## Addendum No. 5

Project Name: NECSD – New CTE Building

CSArch Project No. 108-2303

This Addendum No. 5 forms part of the Contract Documents and modifies the original bidding documents dated April 15, 2024. Addendum No. 5 consists of 3 pages, 9 specification sections, and 31 drawings.

1 WALL SECTION  
A303 1/2" = 1'-0"

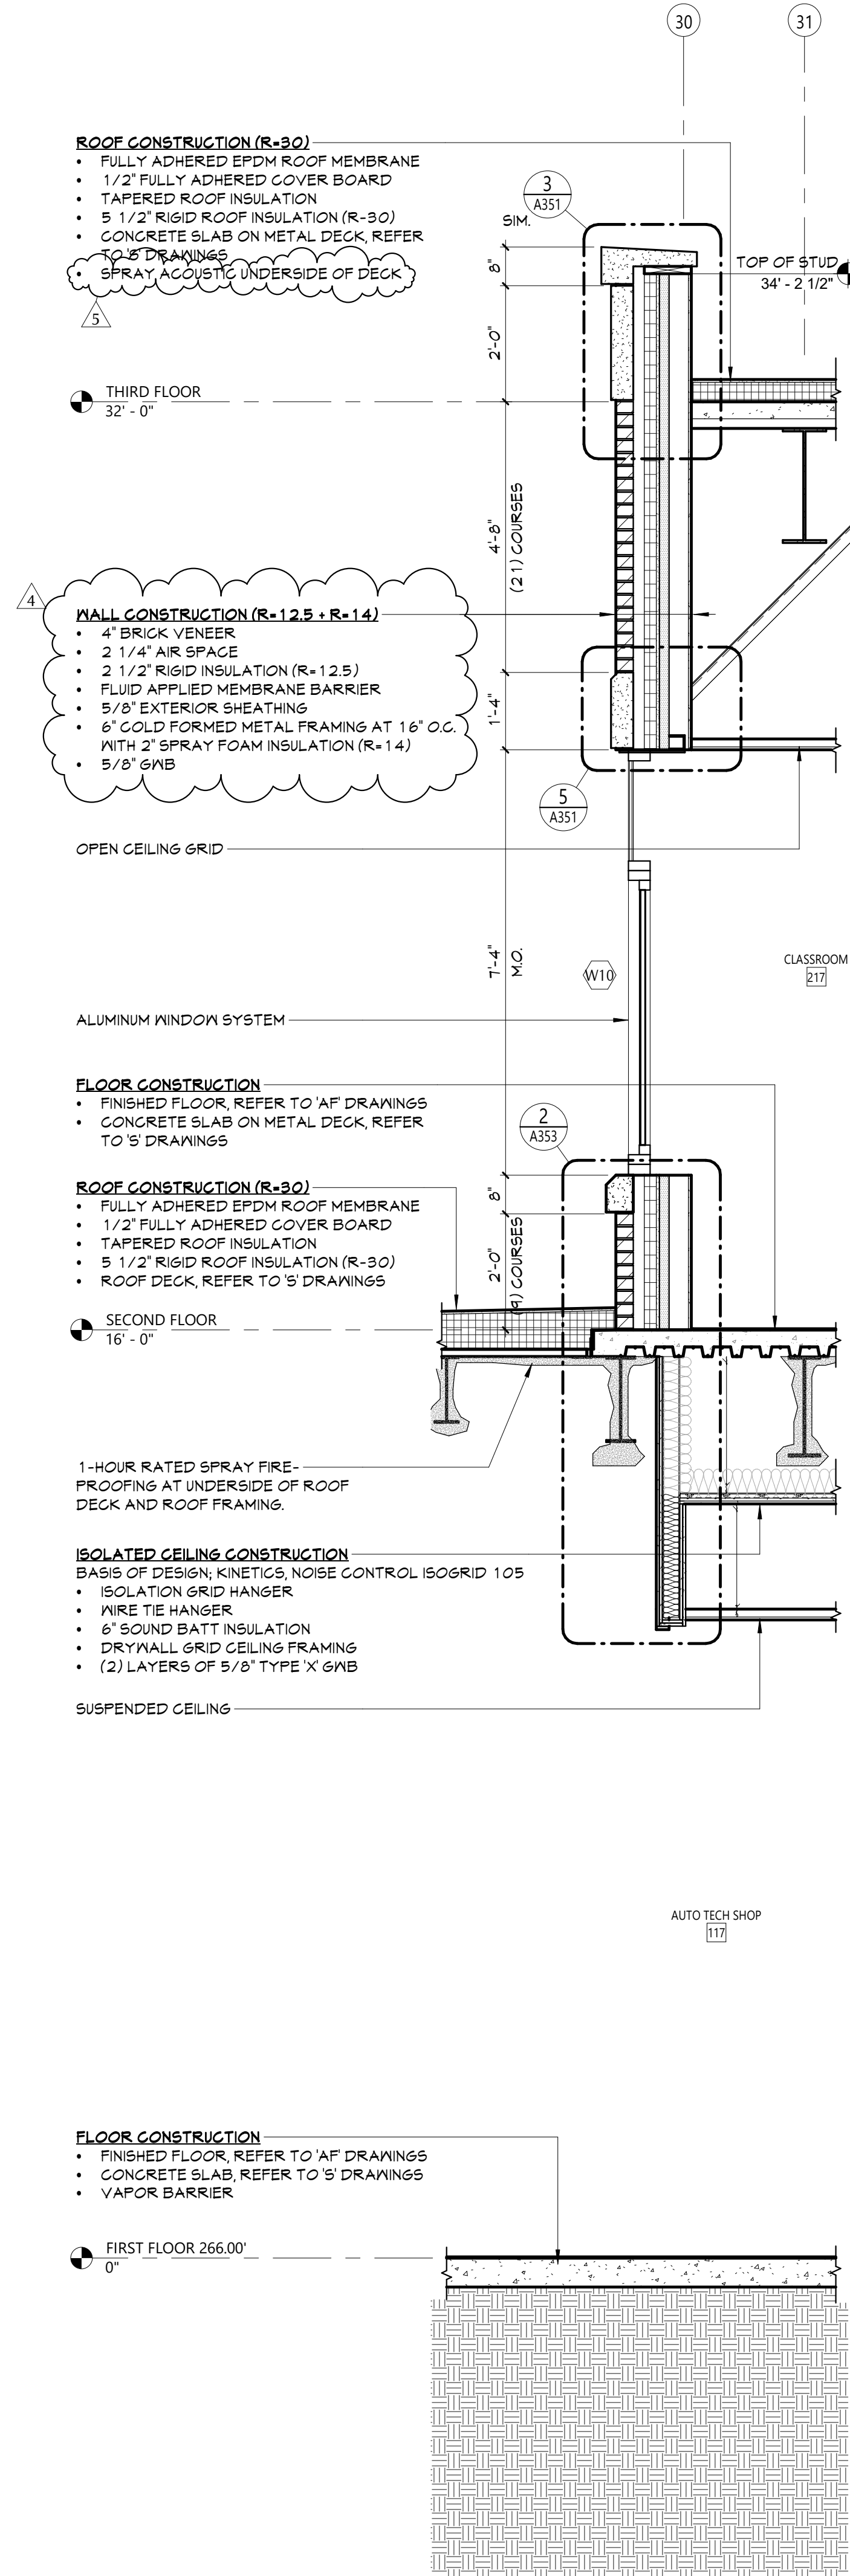
105	A	Wall Construction	Detail 1 of sheet A303 wall construction calls for 8” CMU with fluid applied membrane barrier and 2-1/2” rigid insulation; the wall itself does not match the description it is given. Please clarify if this wall is supposed to be CMU or 6” CFMF with 2” of spray foam insulation as drawn.	5/13/2024	Dobco, Inc.	Revised as part of addendum #4	Yes	A303		Add 4

1 ENLARGED FLOOR PLAN - WELDING SHOP  
A615 1/4" = 1'-0"

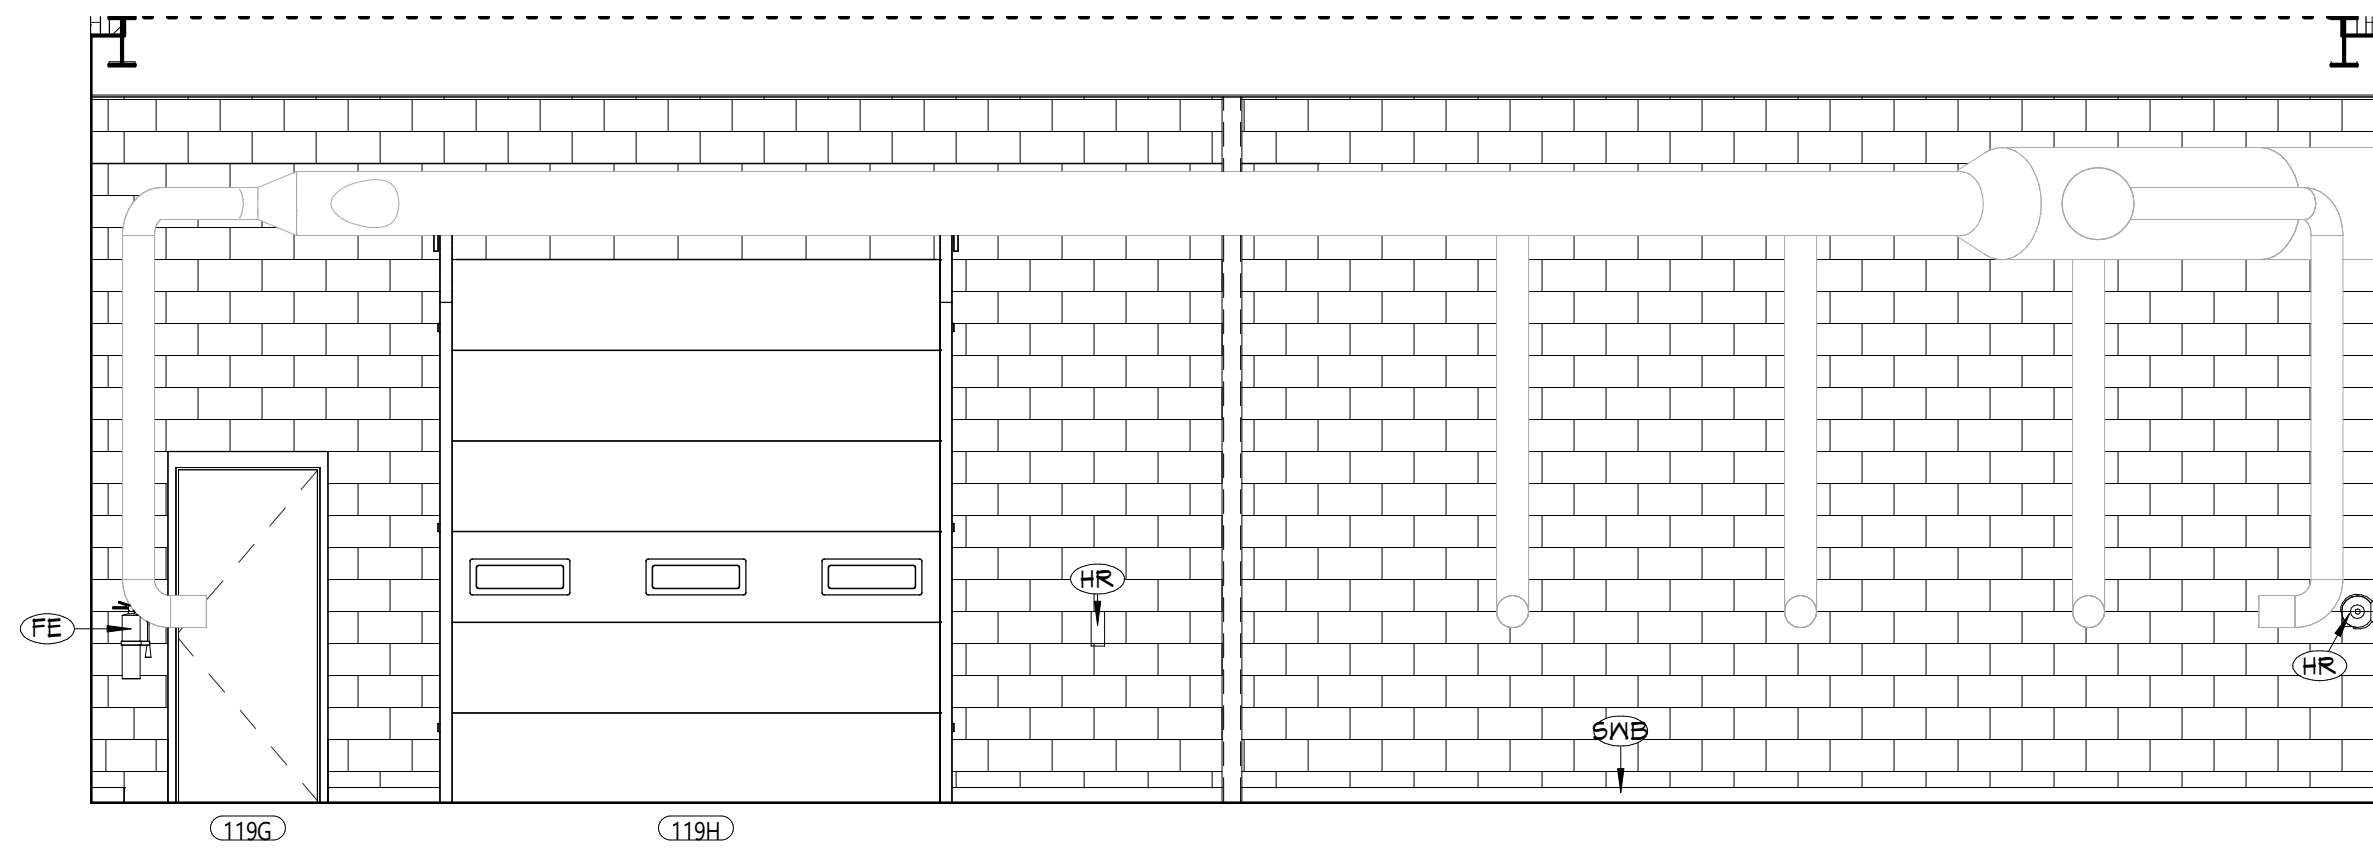
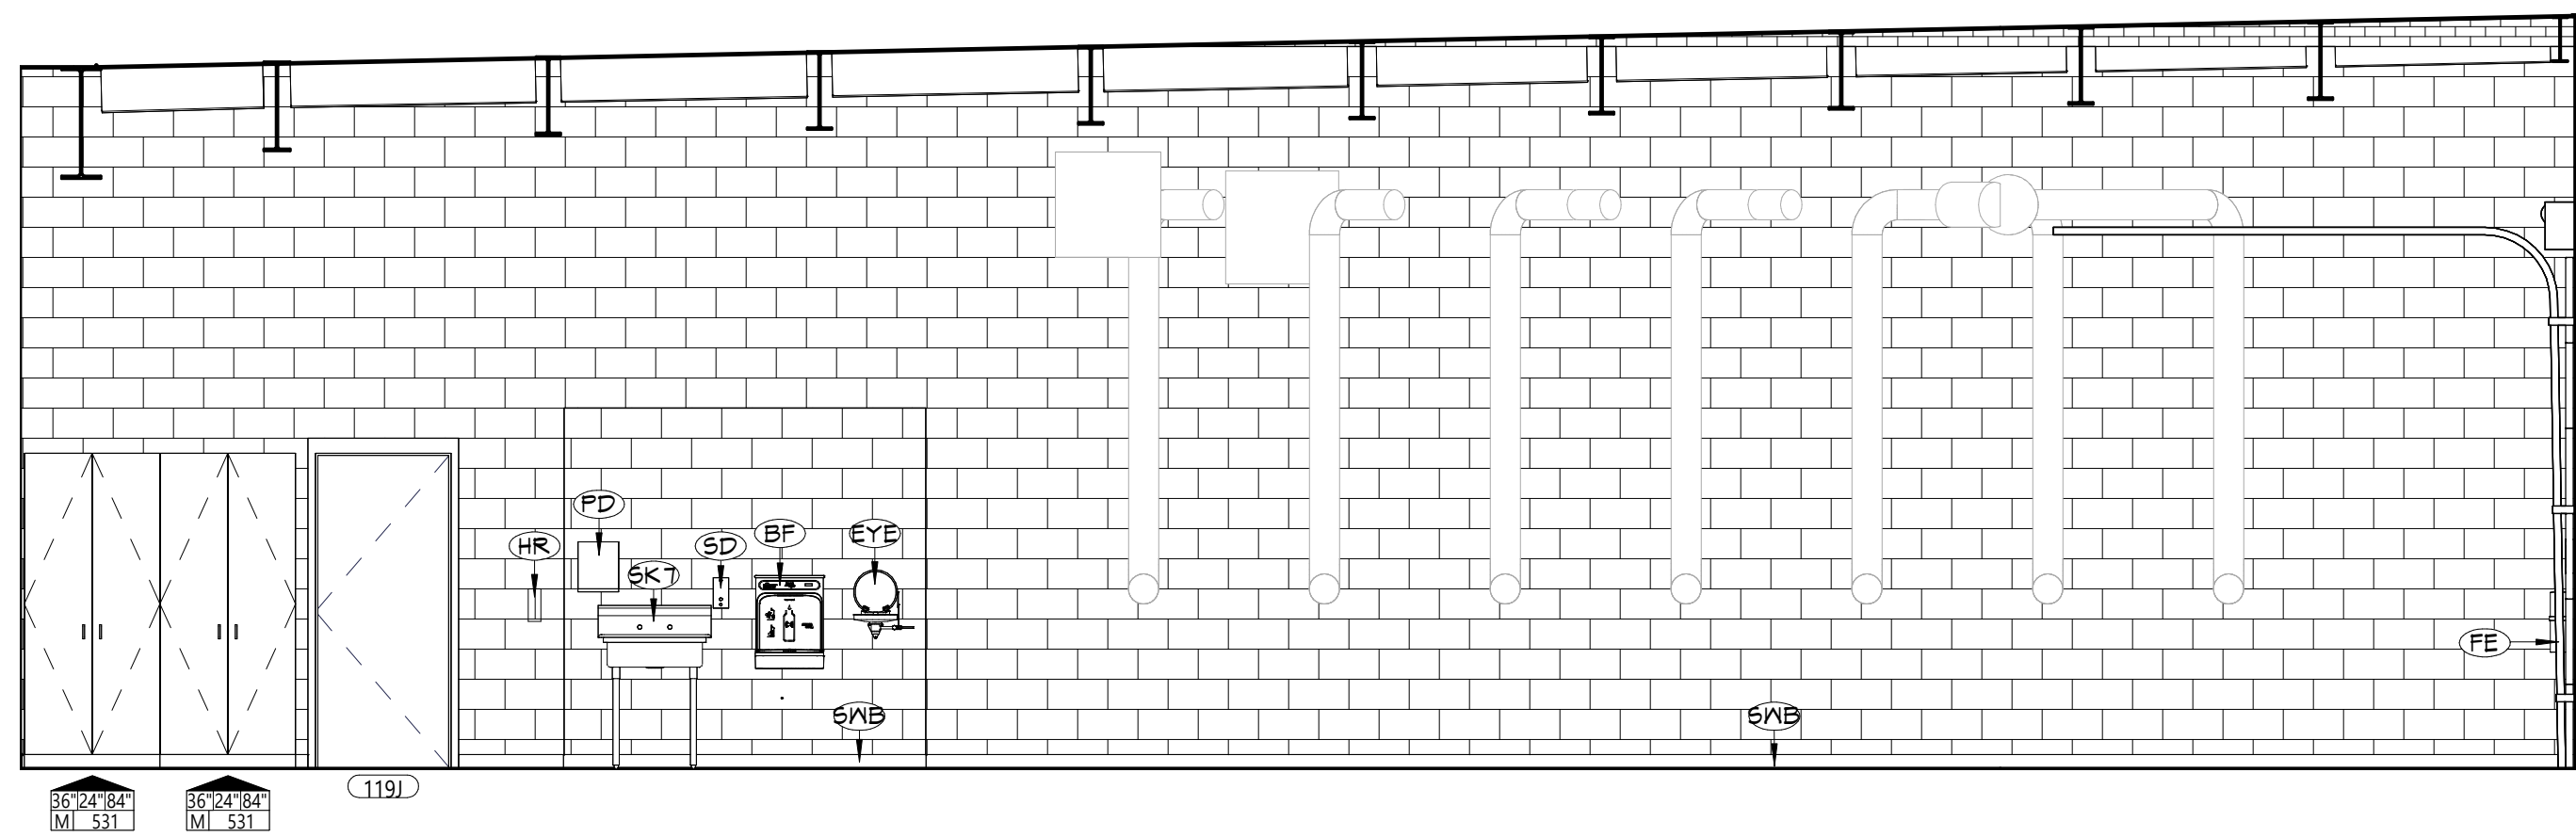
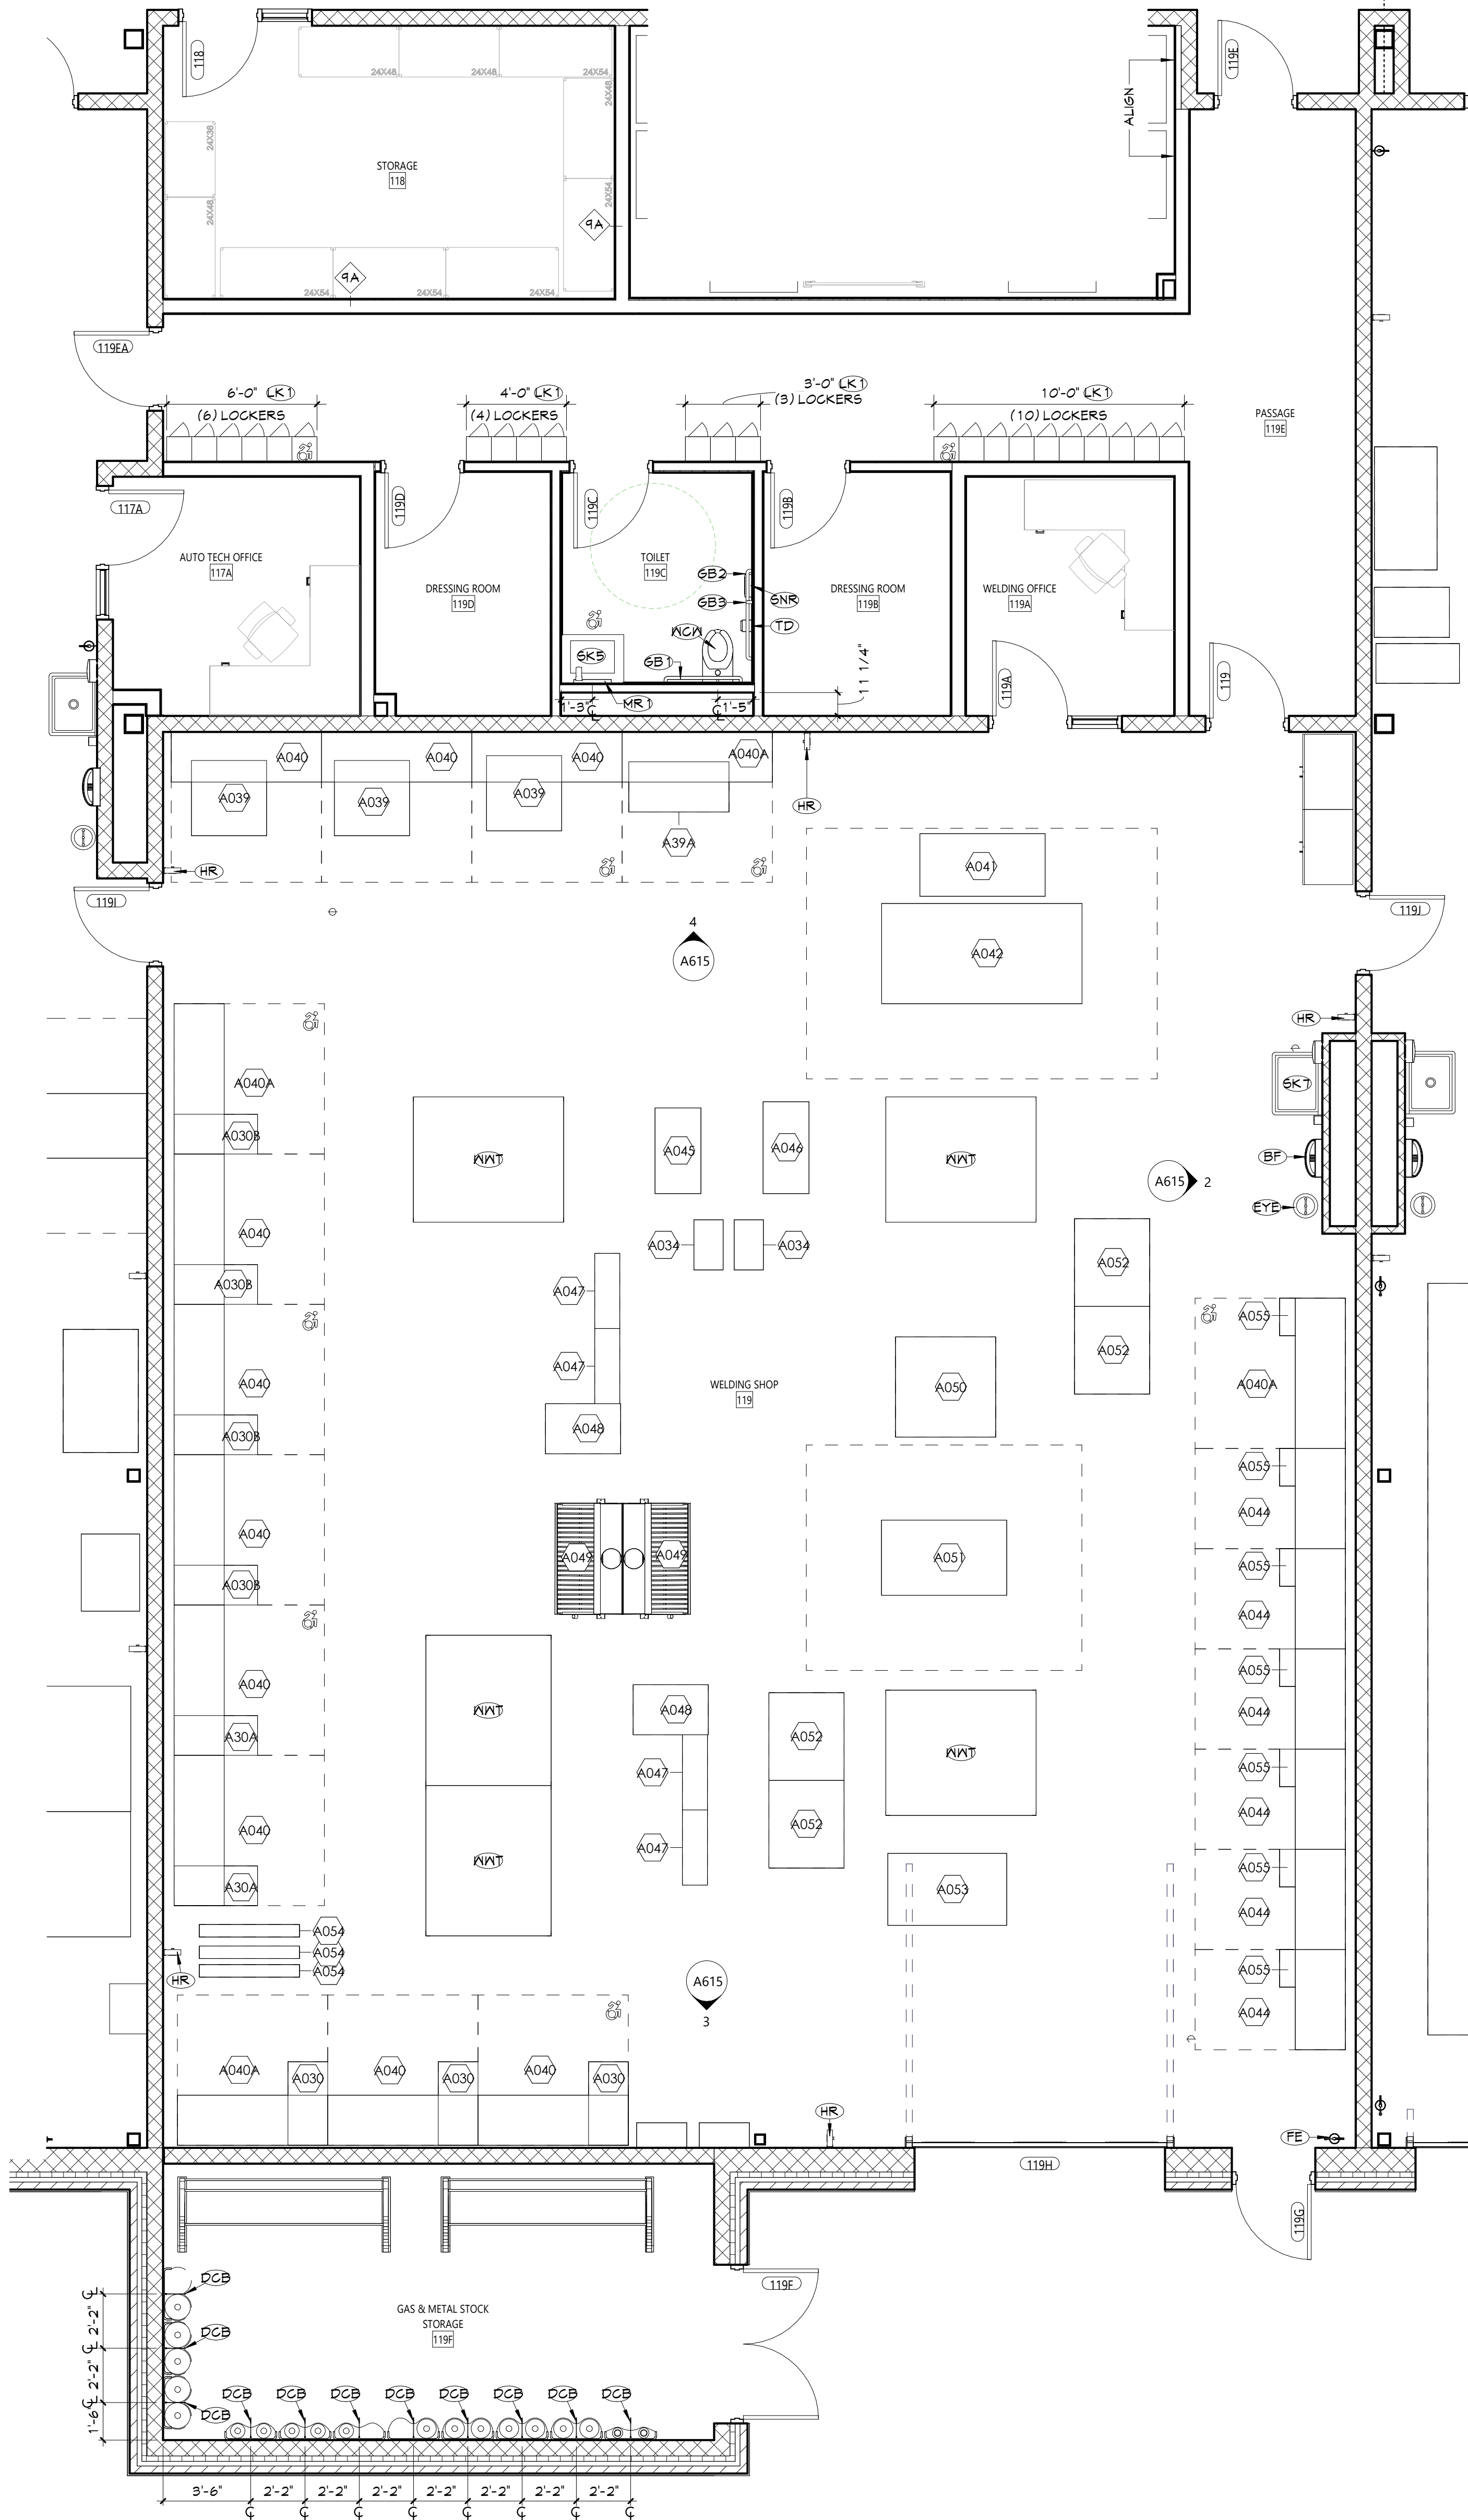
141	T	273100 Telephone System	Is the equipment described in this section owner or contractor furnished? If contractor furnished please identify handset quantities – they aren't show on the drawings.	5/21/2024	Upstate Electric	Telephone devices are furnished by the owner. Revised as part of addendum #5.	Yes		011200.01	Add #5
142	A	Spray Acoustic Treatment	Please confirm the thickness of the Spray Acoustic Treatment is to be ¾" per spec section 09 83 16, part 3.3A, rather than the 2" that is shown on the architectural drawings (ex: A-301 Floor Construction notes).	5/21/2024	Pike Construction Services, Inc.	Thickness to be 3/4". Revised as part of addendum #5.	Yes	A301, A302, A303, A304, A305, A306, A308, A309, A310	098316	Add #5
143	A	Welding Work Tables	Please provide specifications or details for the Welding Work Tables shown on A615 (table height & material, rollers, etc.)	5/21/2024	Pike Construction Services, Inc.	Welding Work Tables are provided by the owner. Revised as part of addendum #5.	Yes	A615		Add #5

150	A	Stair Treads	Please confirm the metal stair tread heights.	5/22/2024	Whiting-Turner	As indicated on detail 11/A354	No			
151	S	Concrete Strength	Please confirm the concrete strength for the metal stair pan infills.	5/22/2024	Whiting-Turner	Refer to specification section 2.3, D. Revised as part of addendum #5.	Yes		055100	Add #5
152	A	Autotech Shop	Please provide specifications for the waste fluid containers for the auto tech shop	5/22/2024	Whiting-Turner	Waste fluid containers are to be owner provided. Revised as part of addendum #5.	Yes	A613		Add #5
153	A	Chain Link Fence	Please provide specifications for the chain link fencing for the auto tech shop.	5/22/2024	Whiting-Turner	Refer to specification section 323113	No			
154	A	Welding Work Tables	Please provide sizes for the welding worktables on Drawing A615 and confirm that the basis of design is Lincoln Electric Co.	5/22/2024	Whiting-Turner	Welding Work Tables identified as WWT on A615 are provided by owner. Welding tables as accessories to the welding booths are indicated in specification	Yes	A615		Add #5
